# HISTORIC AND DESIGN REVIEW COMMISSION

**HDRC CASE NO:** 2023-277  
**ADDRESS:** 502 SHERMAN ST  
**LEGAL DESCRIPTION:** NCB 515 BLK 17 LOT N 104 FT OF 13  
**ZONING:** R-6, H  
**CITY COUNCIL DIST.:** 2  
**DISTRICT:** Dignowity Hill Historic District  
**APPLICANT:** Rogelio Dipp Fuentes /Arangon Builders  
**OWNER:** ARAGON CANAVAN LP  
**TYPE OF WORK:** Window replacement, porch construction, porch modifications  
**APPLICATION RECEIVED:** July 06, 2023  
**60-DAY REVIEW:** September 4, 2023  
**CASE MANAGER:** Jessica Anderson

## REQUEST:

## 3 FRONT COLUMN RECONSTRUCTION

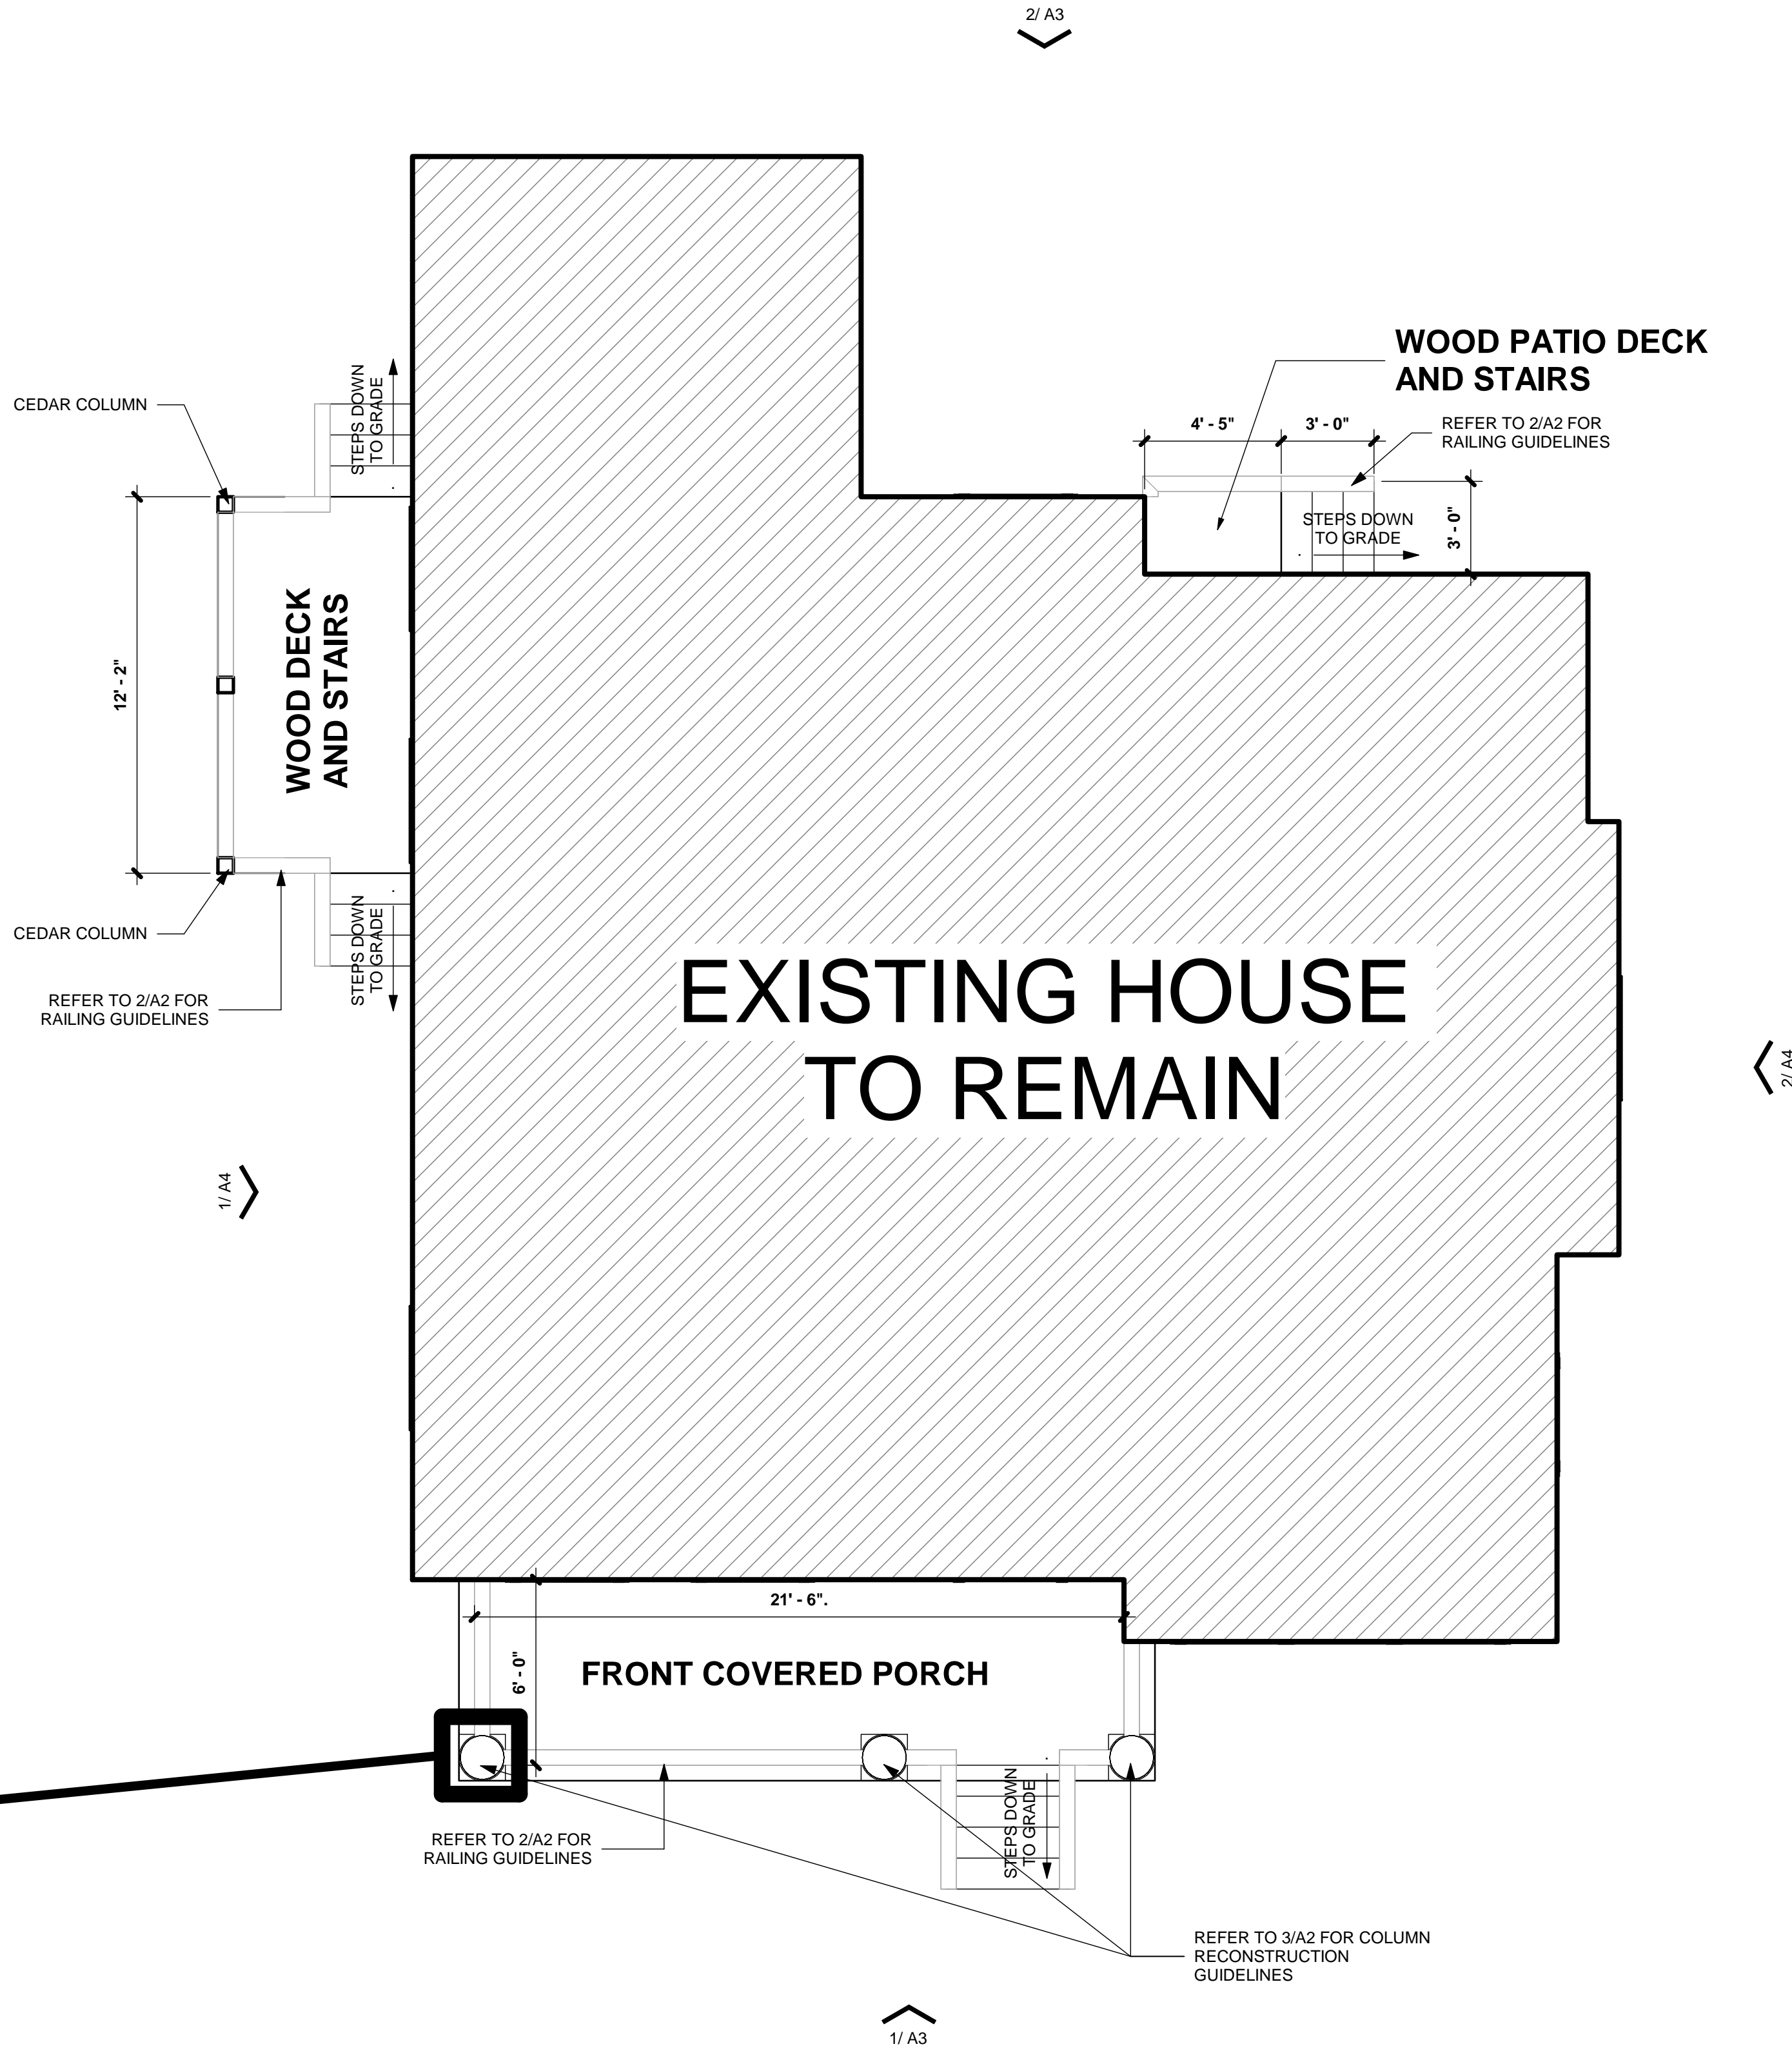
- c. **FRONT PORCH (COLUMNS):** The applicant requests to replace the posts on the front porch with Corinthian columns to match a file photo of the house from 1994-5. Historic Design Guidelines for Exterior Maintenance and Alterations 7.B.v says to reconstruct porches, balconies, and porte-cocheres based on accurate evidence of the original, such as photographs. The file photo shows three columns and one pilaster. Staff finds returning the front porch to this previous condition conforms to guidelines, and that the applicant should install three full columns and one pilaster as seen in the file photo.

- i. That the applicant installs three full columns and one pilaster as seen in the 1994-5 file photo, and noted in finding c.
- ii. That the applicant proposes a window product that conforms to standard specifications, namely a two-over-two product across all elevations and windows that match the historic configuration for the three ganged front windows, as seen in the 1994-5 file photo, as noted in finding e.

# 502 Sherman 1993-4.png

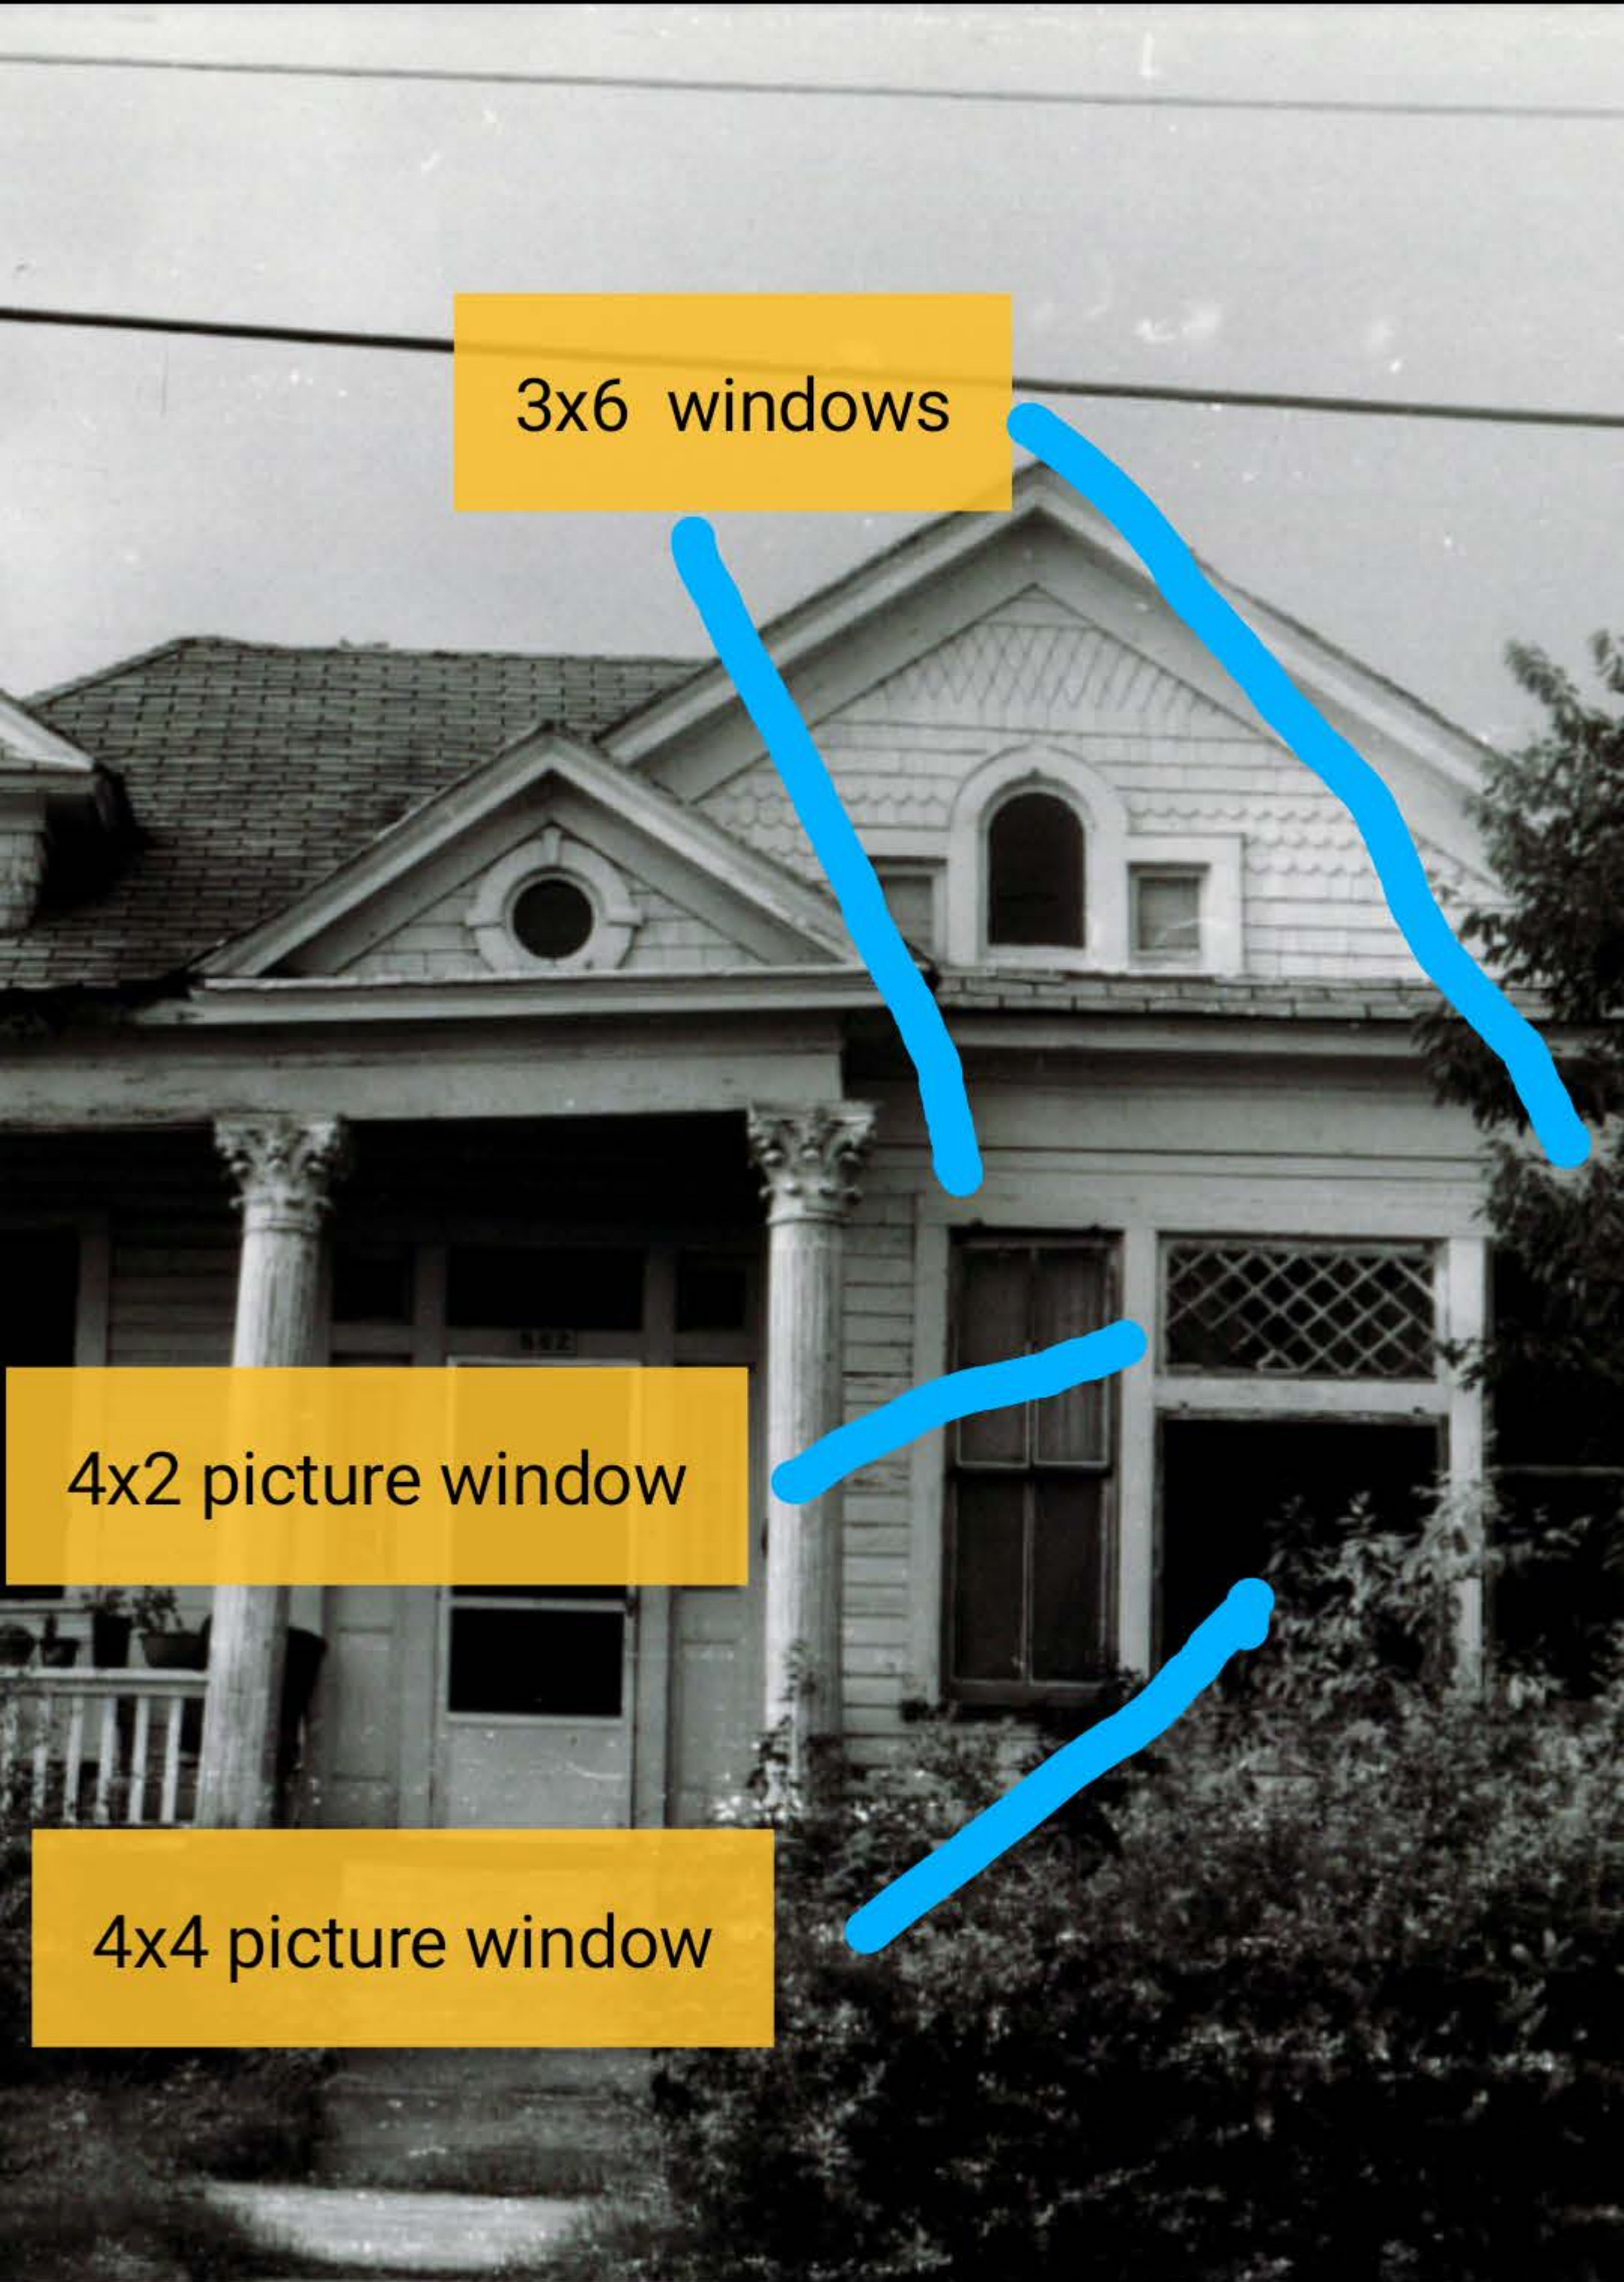
- e. **WINDOWS:** The applicant requests to install new one-over-one wood windows across all elevations of the house. Any wood windows previously found on the home have been removed and boarded or replaced with metal-sash windows. A file photo of the house from 1994-5 shows a ganged set of three windows on the front of the house, with a central decorative-lite window above a single-lite window flanked by two windows, the left of which features a two-over-two configuration. Standard specifications for wood window replacement state that whole window systems should match the size of historic windows on property unless otherwise approved. The applicant proposes to install one-over-one wood windows across all elevations, and to replace the three ganged windows on the primary elevation with a 4'x2' fixed window above a 4'x'4' fixed window, flanked by one-over-one 3'x6' windows. Staff finds the applicant should propose a window product that conforms to standard specifications, namely a two-over-two product across all elevations and windows that match the historic configuration for the three ganged front windows, as seen in the 1994-5 file photo.
